Variation of the Spectrum Access Licence for 1452-1492MHz and changes for fixed link use in the paired bands 1350-1375 MHz and 1492-1517 MHz

Consultation on a licence variation request to enable
MFCN SDL (Mobile/Fixed Communication Network
Supplemental downlink) in the 1452-1492 MHz band

Consultation

Publication date: 30 September 2014

Figure 1.1: High level band diagram showing changes to the 1.4 GHz fixed link band

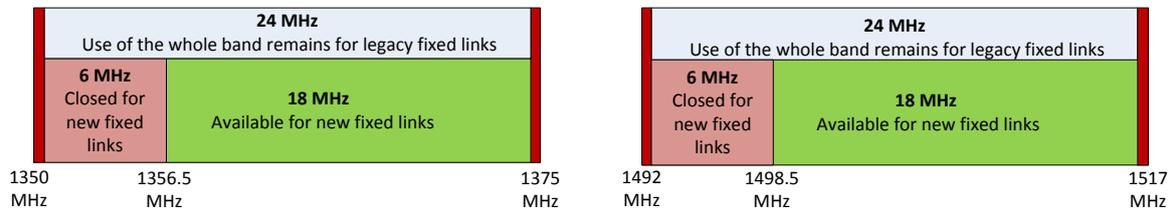
- 1.17 Following the variation of the Spectrum Access Licence for 1452-1492 MHz, Ofcom would continue to assign new fixed links (or to vary existing assignments) but these would be limited to having access to channels in the 1498.5 – 1517 MHz range paired with the lower sub band 1356.5 -1375 MHz. This is shown in figure 1.1 below:

- 1.18 On the date of the licence variation, our proposal would reverse the fixed link assignment algorithm for this band to assign fixed link channels from the top of the band downwards (i.e. from 1517 MHz) rather than from the bottom up, as at present.

Figure 4.1: Band diagrams showing possible frequency separations

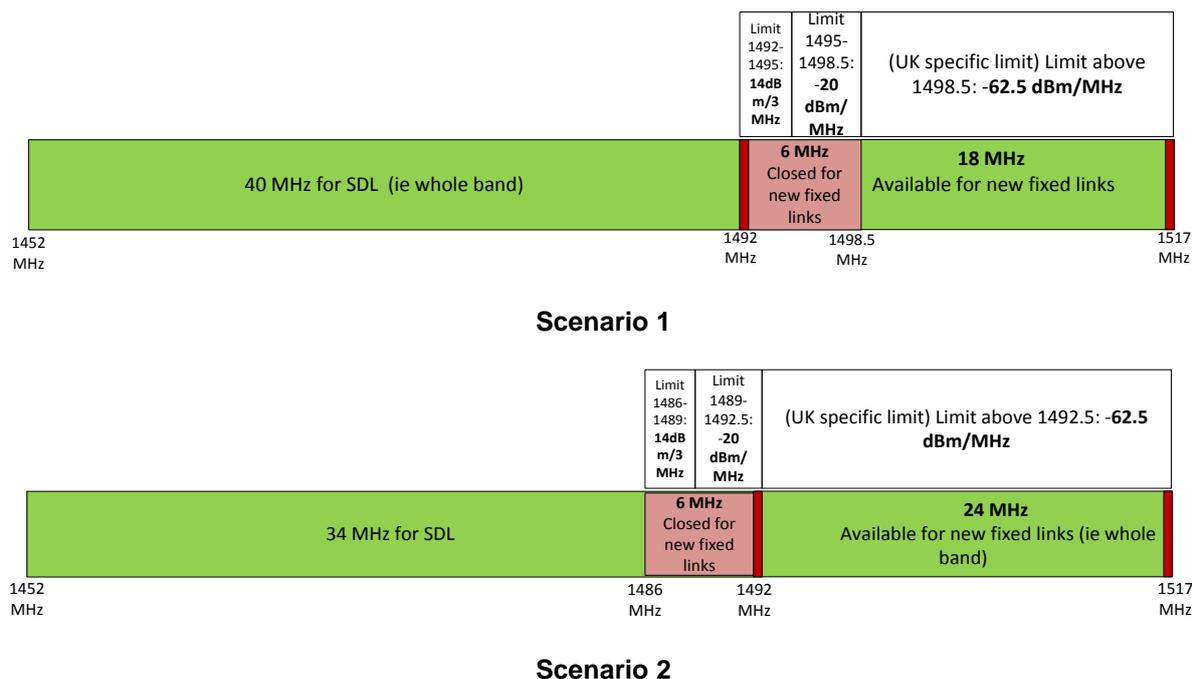
- 4.4 The Qualcomm licence variation request would place the additional 6 MHz gap at the bottom of the existing fixed link band between 1492.5-1498.5 MHz (this is “scenario 1” in the top part of figure 4.1 below). However, it would be possible, in principle, to leave all of the existing fixed link band open to new assignments as now and to place the additional 6 MHz gap at 1486-1492 MHz at the top of the Qualcomm licenced spectrum (as in “scenario 2” in the bottom part of figure 4.1 below).

4.5 Although scenario 2 would not be consistent with the spectrum allocation implied by the ECC Decision, we consider it appropriate to assess which of these two scenarios (for the Qualcomm licence variation and associated fixed link licensing changes) is most likely to promote the optimal use of spectrum. The bulk of this section summarises this assessment. However, we comment again on the implications of potential European harmonisation in paragraphs 4.47 to 4.48 below.

Figure 5.1: High level band diagram showing changes to the 1.4 GHz fixed link band

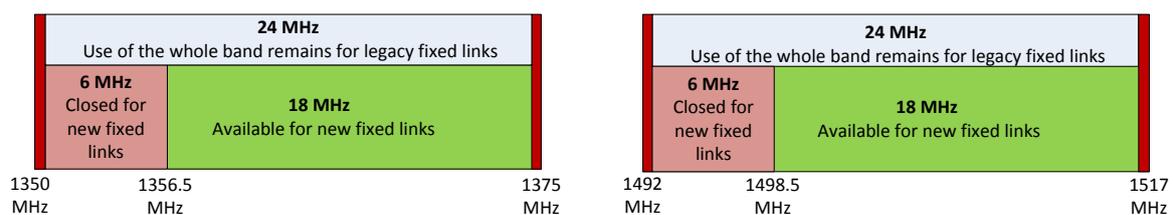
- 5.10 Our proposals would enable existing licensed fixed links to continue to operate across the 1492-1517 MHz (and paired sub band 1350-1375 MHz) in accordance with their assigned parameters. These links would have the status of legacy links on the date of the 1452-1492 MHz licence variation and would have protection from undue interference from future SDL deployments in the 1452-1492 MHz band.
- 5.11 Following the variation of the Spectrum Access Licence for 1452-1492 MHz, Ofcom would continue to assign new fixed links (or to vary existing assignments) but these would be limited to having access to channels in the 1498.5 – 1517 MHz range paired with the lower sub band 1356.5 -1375 MHz. This is shown in figure 5.1 below, whilst table 5.2 shows the number of channels that would remain available.
